**17SUBDIV1009 &  
17STREETS108  
Glen Lakes Subdivision**

**Louisville Metro Planning Commission Public Hearing**

**Laura L. Mattingly, Planner II**

**June 29, 2017**

# Applicant's Development Plan

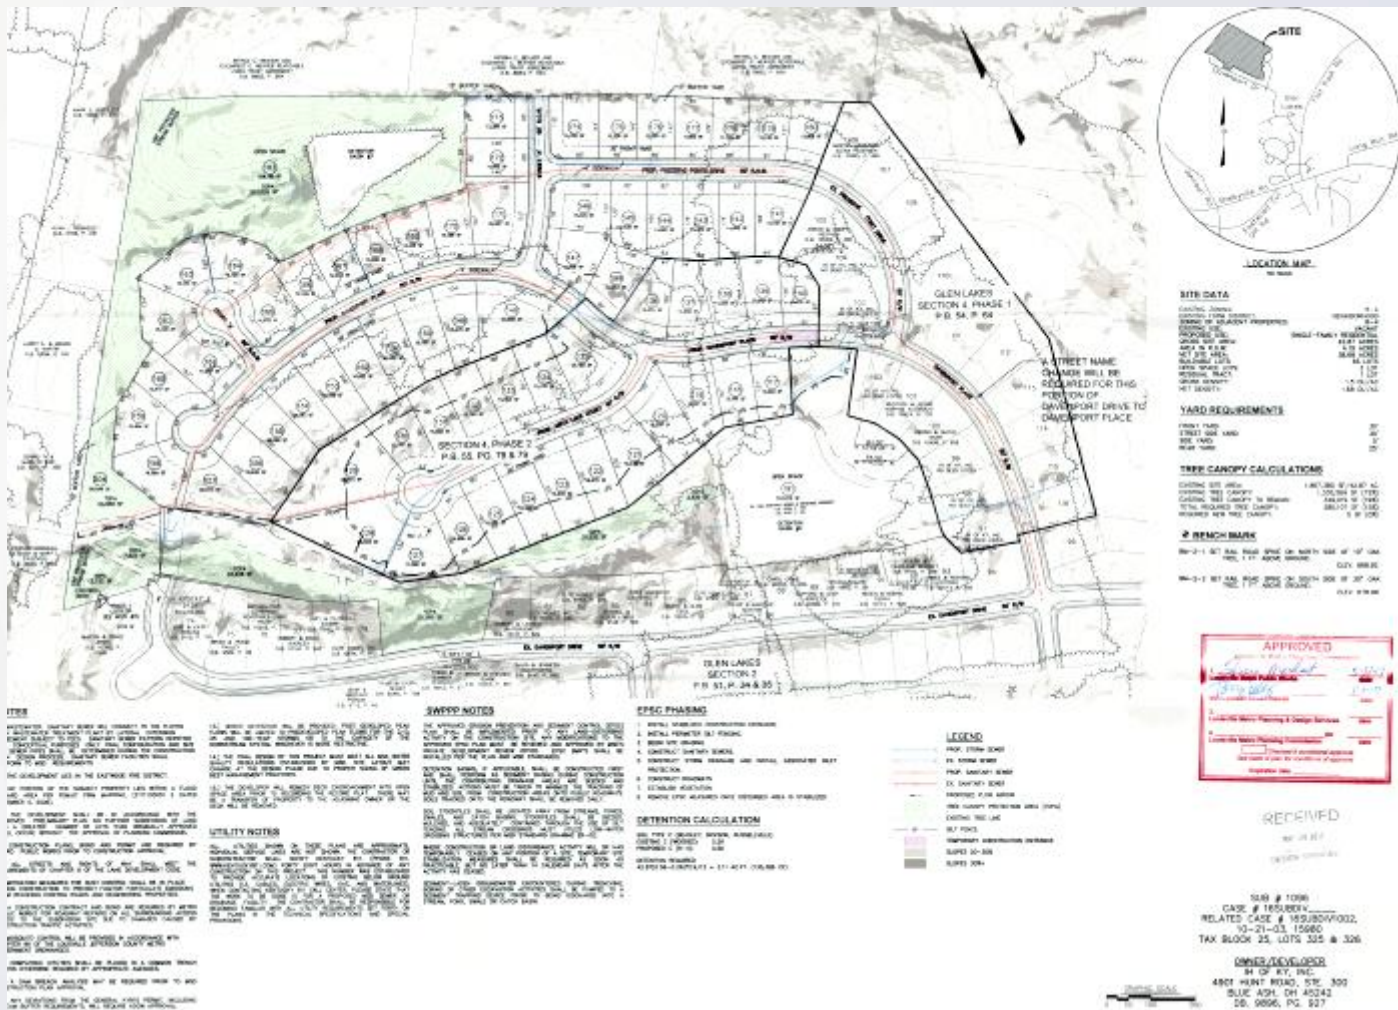
- Subdivision Plan continued from June 29, 2017 Planning Commission
- Revise Section 4 of the Glen Lakes subdivision to create a cul-de-sac on the west side of the proposed Davenport Place in place of a connection to Davenport Drive
- Request street name change from Davenport Drive to Treesdale Drive on the north/south portion from Glen Lakes Drive to Section 4

- The subdivision plan is in order and has received preliminary approvals from Transportation and MSD.
- The street name change request has been approved by E-911/MetroSafe
